RE: Sanitary Sewer Rehabilitation
City of Tama
DNR Project No. S2013-0103
CWSRF No. CS1920669 01

Subject: Variance Request from 567 IAC 64.2(9) and Design Standards Section
12.4, 12.5.3 and 12.6

VARIANCE REQUEST
Iowa Department of Natural Resources

RE: City of Tama Sanitary Sewer Rehabilitation S2013-0103
 Wastewater Construction Variance Request

Sheet C.06

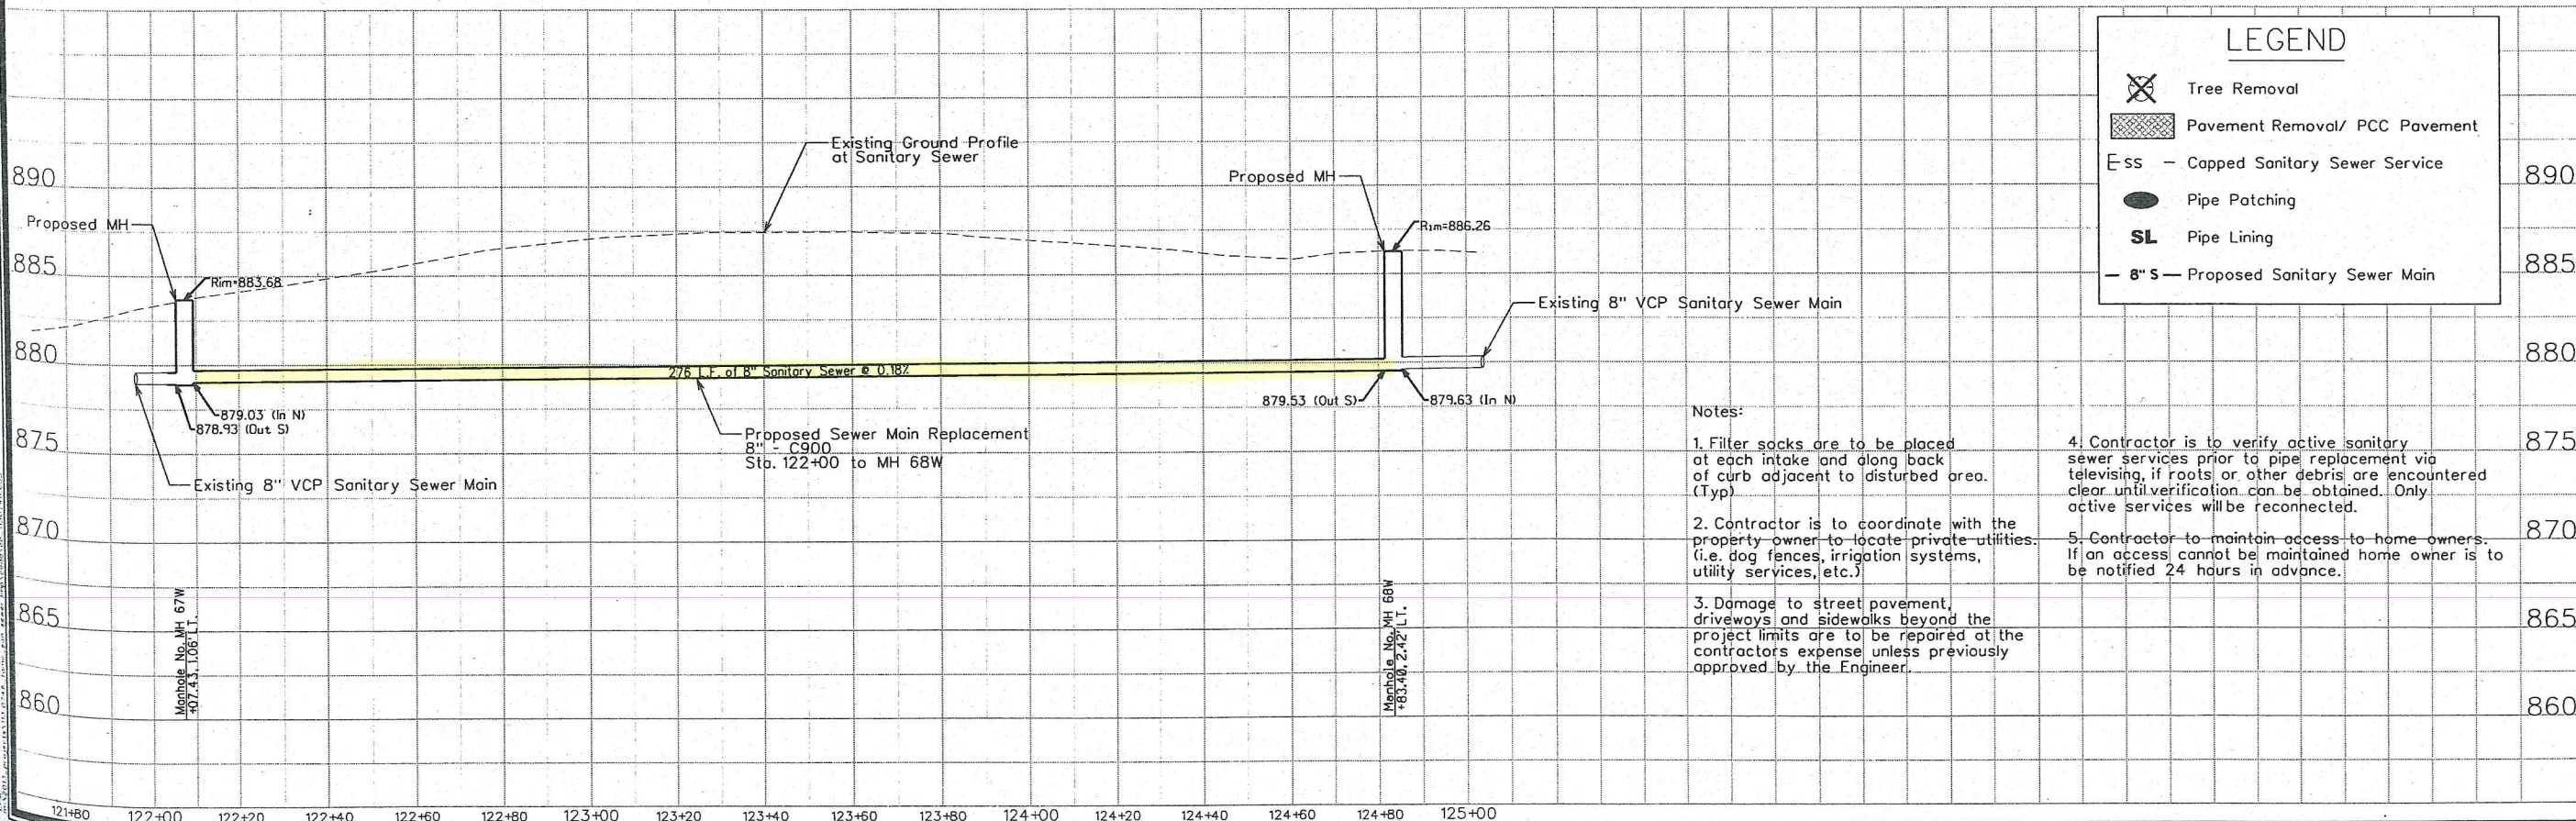
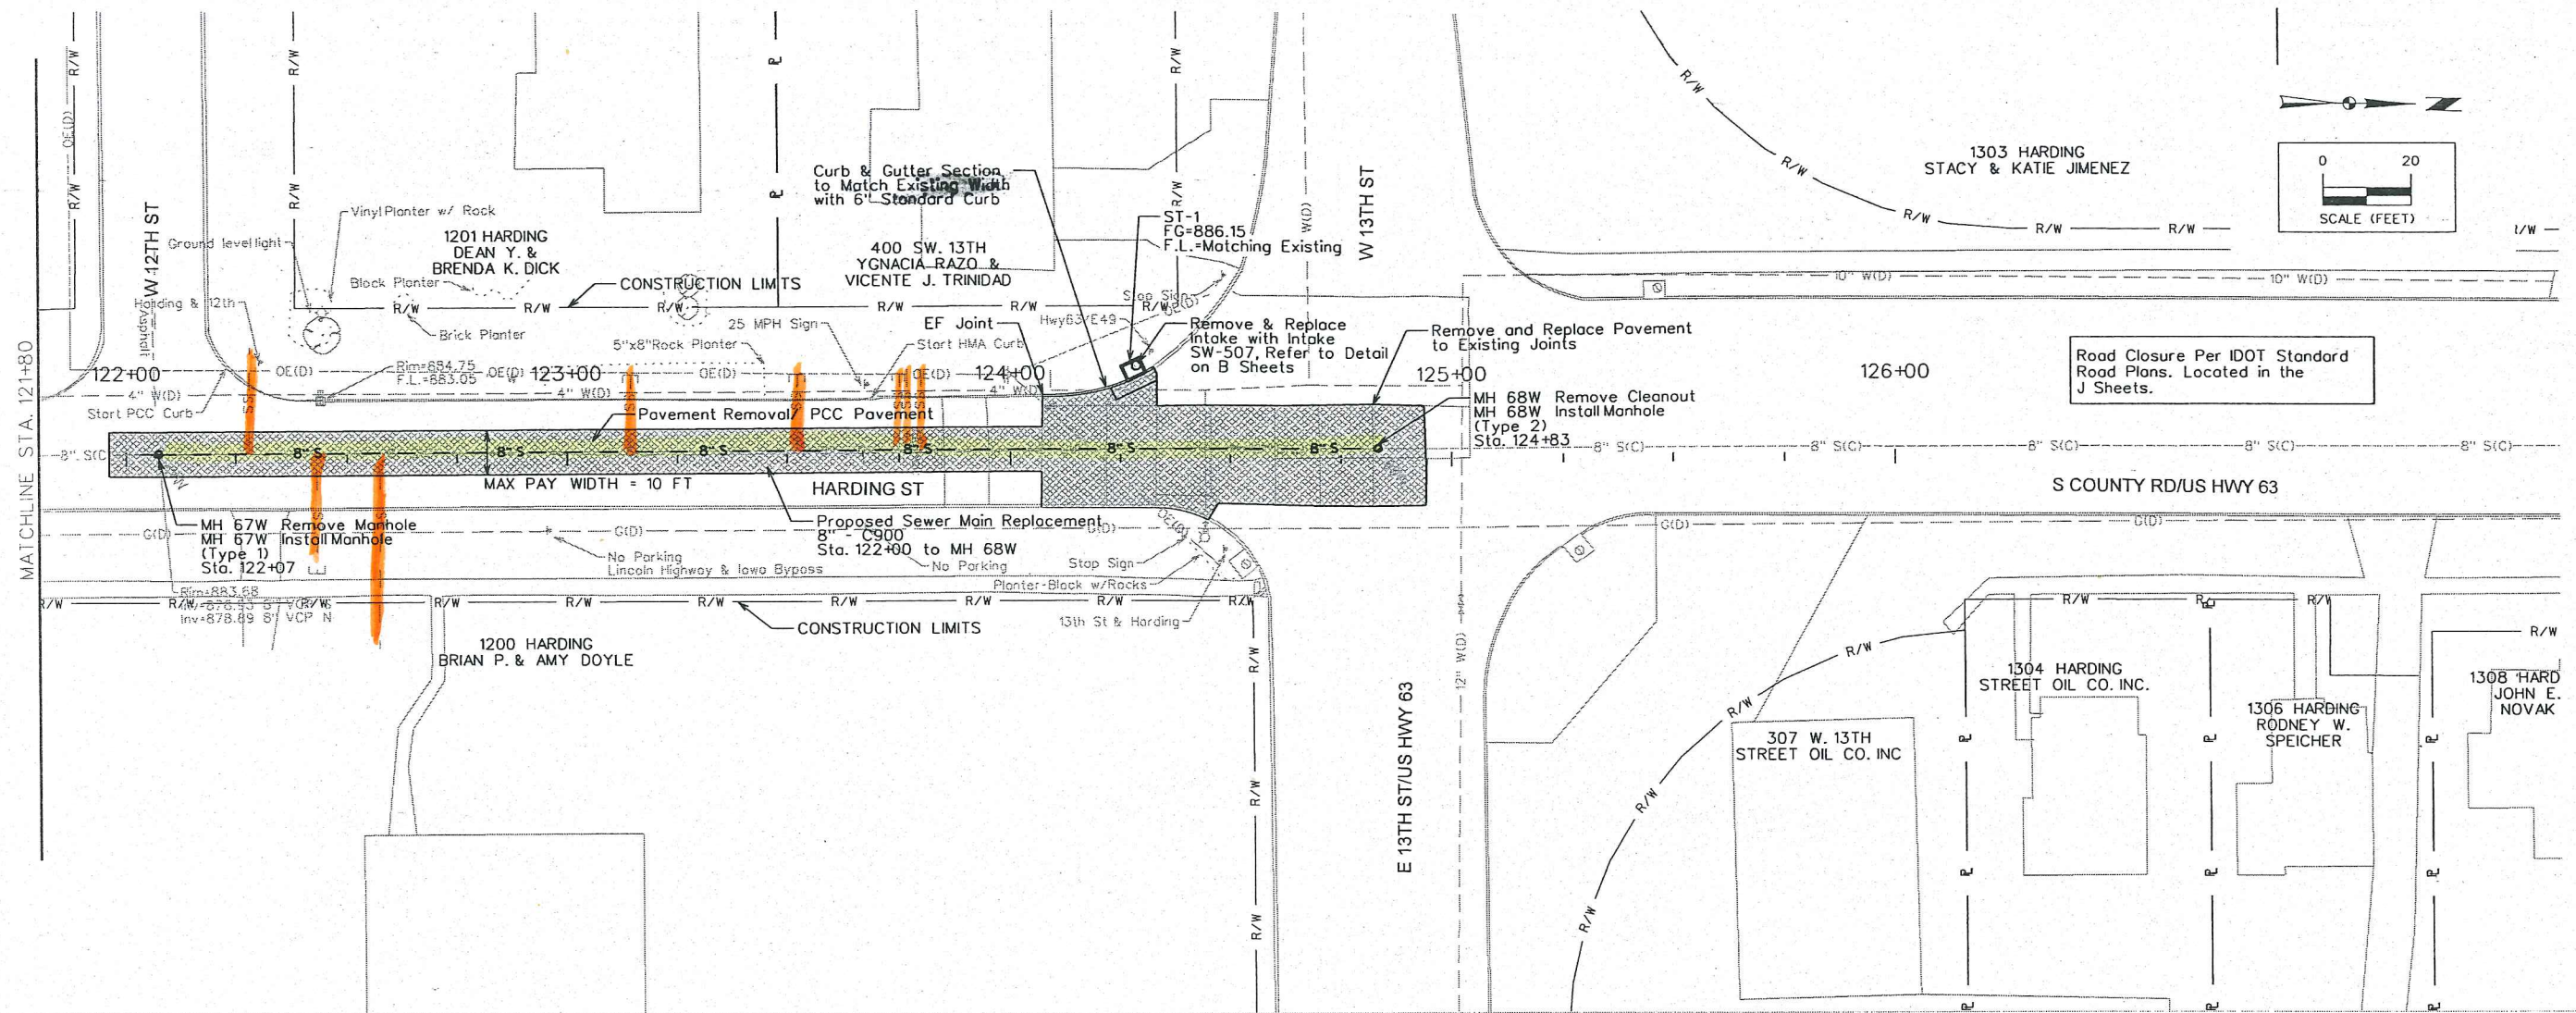
The City of Tama is requesting variance from the Iowa Wastewater Facilities Design Standards Chapter 12 - Iowa Standards for Sewer Systems - 12.4 (Materials) and 12.6 (Details of Construction) for the installation of gravity sewers by pipe bursting utilizing HDPE (high density polyethylene) pipe. The proposed sewer material and installation method is not covered in the Iowa Wastewater Facilities Design Standards.

To minimize impacts to existing infrastructure, pipe bursting is being considered as an alternative construction measure. Proposed 8-inch sanitary sewer replacement, as shown in the "Sanitary Sewer Pipe Bursting Table - Alternate Bid" on Sheet C.06, indicates sections of proposed sanitary sewer pipe lining or pipe replacement that may alternately be performed as pipe bursting. Pipe bursting is being bid as an alternate and will be ultimately decided following the bid letting, dependent upon relative pricing. These bid items are for pipe bursting utilizing HDPE pipe in lieu of open cut installation utilizing AWWA C900 pipe. HDPE is the pipe material commonly used for pipe bursting sewer installations.

Pipe bursting has been approved by the Department by variance at many other locations in the past. The proposed installation makes a clear improvement over the existing condition of the sewer line and these methods are justified by the interference of the existing properties.

The submitted construction drawings show that installing this sewer by open trench methods would result in the site disruption for several property owners in that area. The use of the pipe bursting technology will eliminate the potential disruption and damage of the standard open trench installation method and could provide a cost savings. The Engineer and City will be able to verify cost savings by bidding pipe bursting as an add alternate.

- 4. The relevant facts that the petitioner believes would justify a waiver or variance:
 - a. To minimize impacts to existing infrastructure, pipe bursting is being considered as an alternative construction measure. Proposed 8" sewer replacement, as shown in the "Sanitary Sewer Pipe Bursting Table – Alternate Bid" on Sheet C.06, indicates sections of proposed sanitary sewer pipe lining or pipe replacement that may alternately performed as pipe bursting. Pipe bursting is being bid as an alternate and will be ultimately decided following the bid letting, dependent upon relative pricing. These bid items utilize HDPE pipe in lieu of open cut installation of AWWA C900 pipe as specified for the remainder of the project. HDPE is the pipe material commonly used for pipe bursting sewer installations.

After careful and thorough consideration, the Department has approved your March 23, 2015 request for a variance from Iowa Administrative Code Subrule 64.2(9) and Chapter 12.4, 12.5.3 and 12.6 of the Iowa Wastewater Facilities Design Standards, which specifies sewer material, minimum slope for gravity sewers, and installation methods for gravity sewers.

Based on the documentation presented by your Engineer, it is the determination of this Department that satisfactory justification has been presented to warrant the granting of a variance for the installation of a gravity sewer with a slope of 0.18% and installation of gravity sewers by pipe bursting methods utilizing HDPE pipe. The requested variance is deemed to be reasonable and necessary pursuant to the Iowa Code section 455B.181.

Project No: 1130746
Sheet D.03

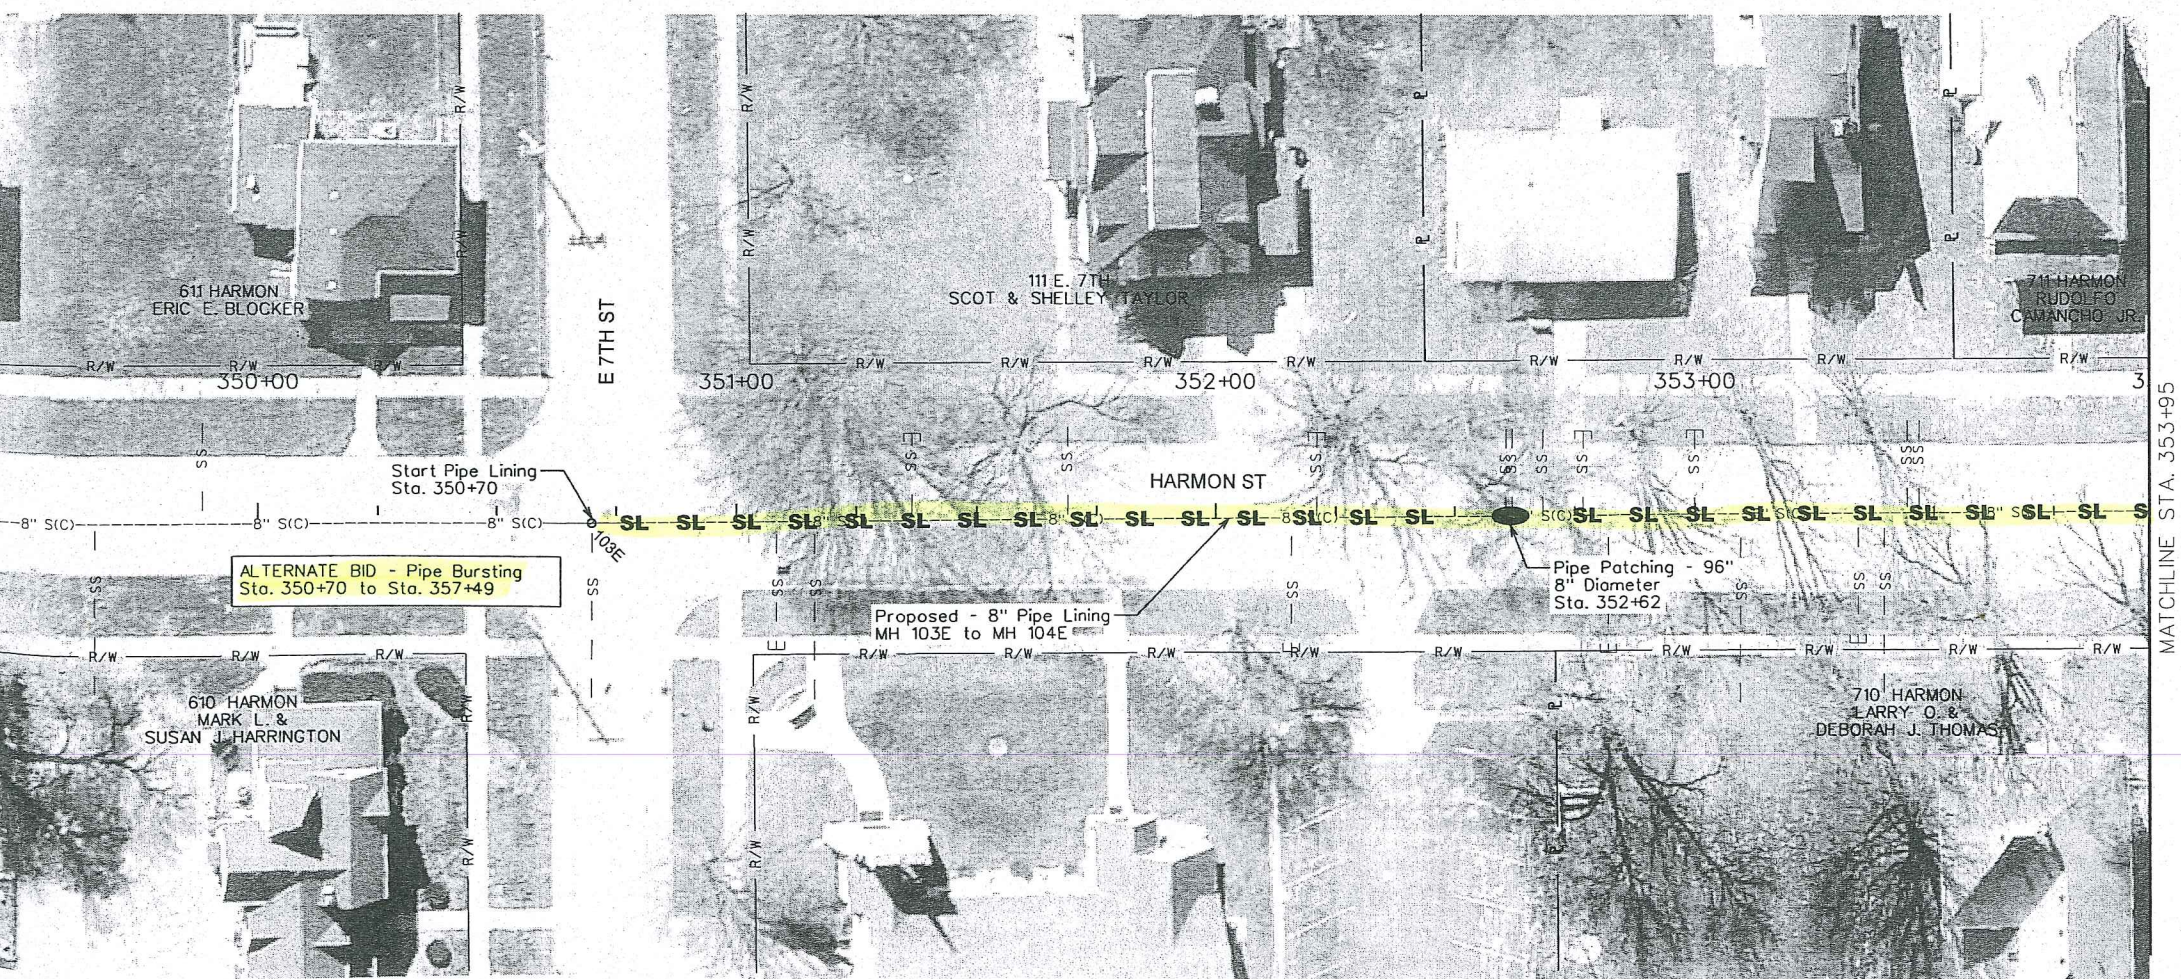
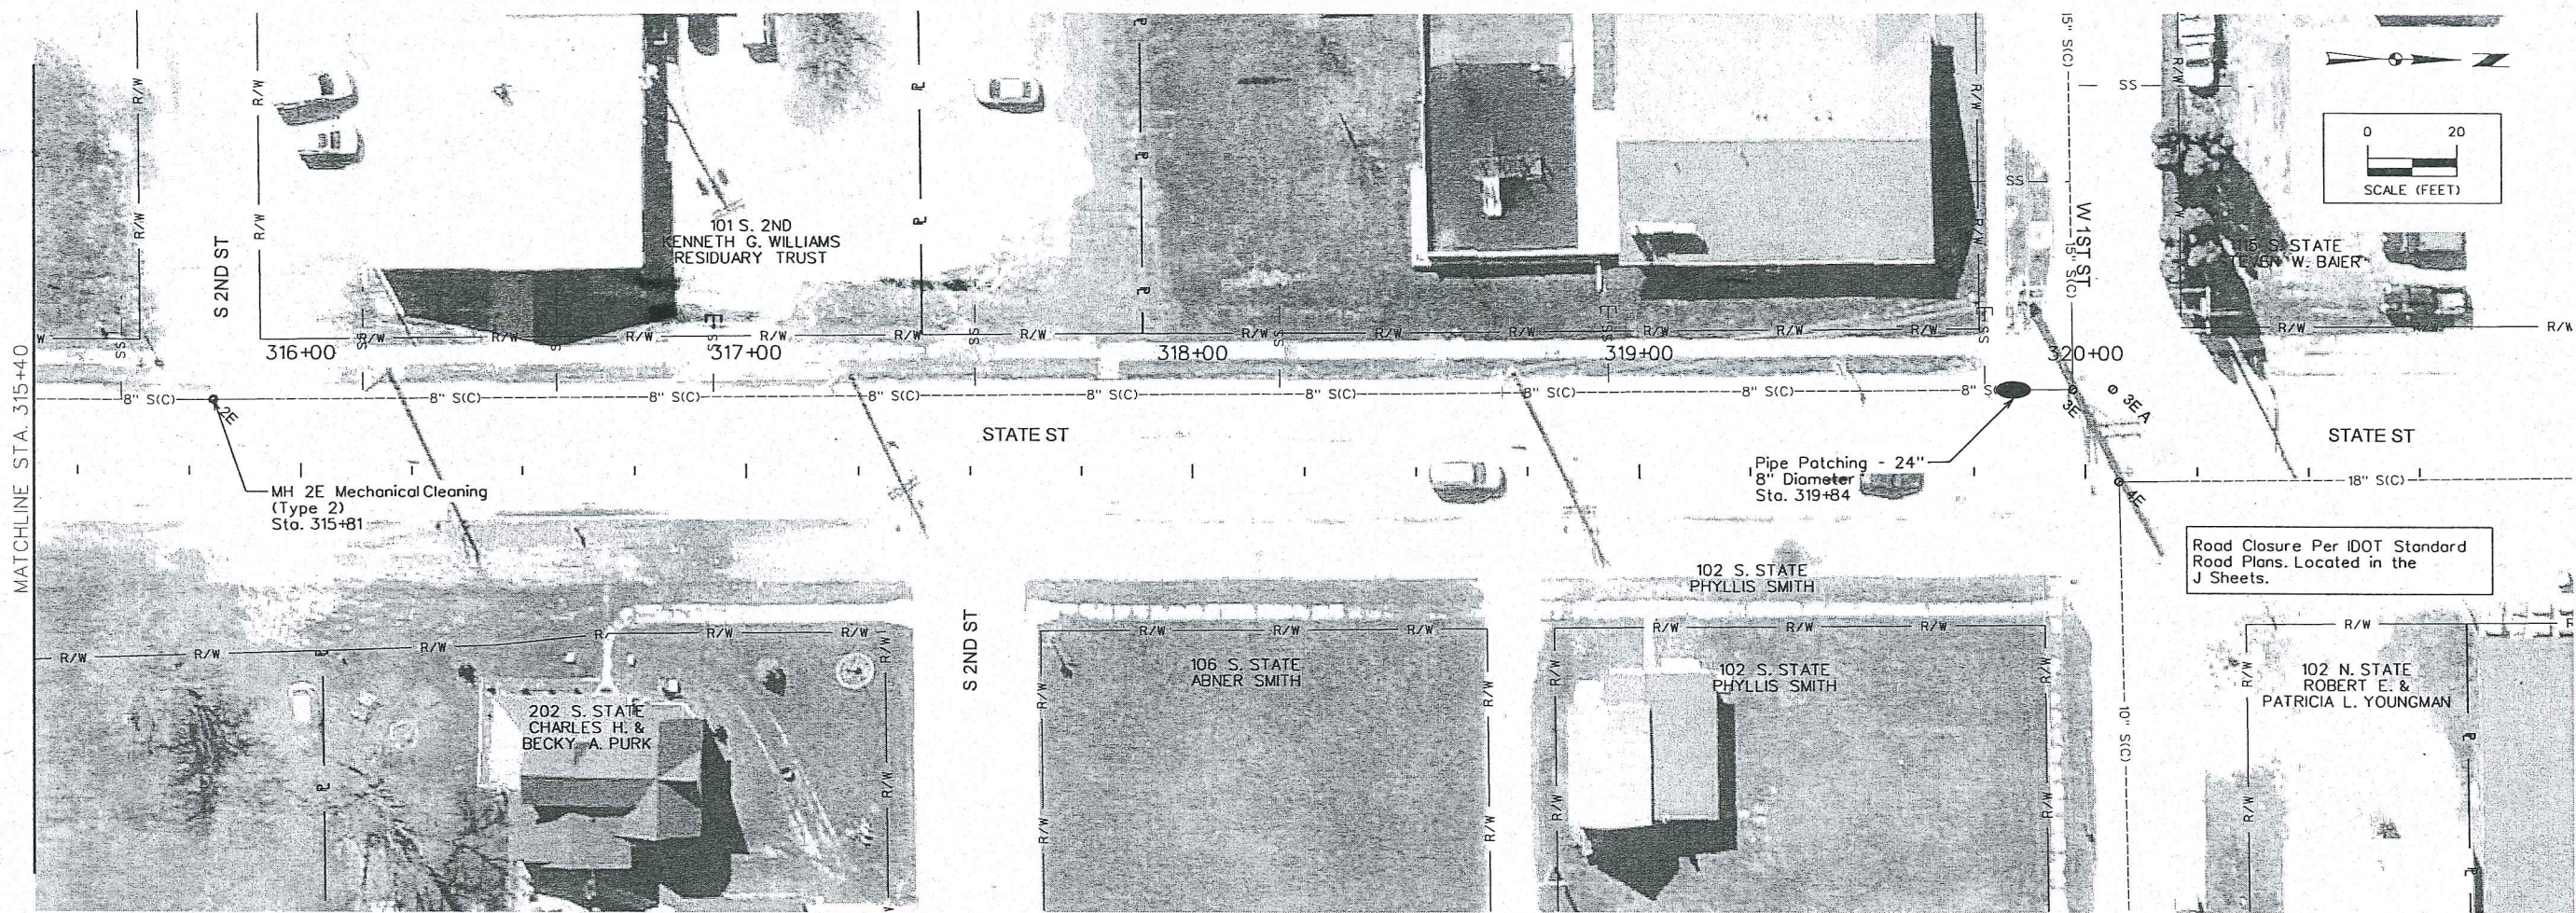
The City of Tama is requesting variance from the Iowa Wastewater Facilities Design Standards Chapter 12 - Iowa Standards for Sewer Systems - 12.5.3 (Slope) for the replacement of one section of existing 8-inch gravity sanitary sewer line at a slope less than those specified in the design standards. The slope proposed is 0.18% in lieu of the required minimum slope of 0.40%.

The proposed 8-inch sanitary sewer replacement from MH 68W to MH 67W on Harding Street, as shown on Sheet D.03, is limited to the slope of the existing sewer due to the positioning of both the upstream and downstream sewer main.

With the fixed upstream and downstream elevations and the elevation of the service lines in the existing system, a great deal of additional work and expense would be required to install the sewer line at the slightly steeper required slope of 0.40%.

The proposed slope of 0.18% gives a velocity of 1.55 fps at 3/4 depth and 1.34 fps at full flow. Proposed design flow for this portion of sewer is 0.031MGD and the design capacity of an 8-inch sewer line installed at 0.18% is 0.301MGD. Therefore installing the sewer line at 0.18% will provide adequate capacity.

- b. The variance requested is a pipe slope of less than the minimum slope as outlined in Chapter 12, Section 12.5.
 - i. Scope of the variance relates to the 8" section from MH 68W to MH 67W on Harding Street, as shown on Sheet D.03.

- b. Proposed 8" sewer replacement from MH 68W to MH 67W on Harding Street, as shown on Sheet D.03, is limited to the slope of the existing sewer due to the positioning of both upstream and downstream sewer main.
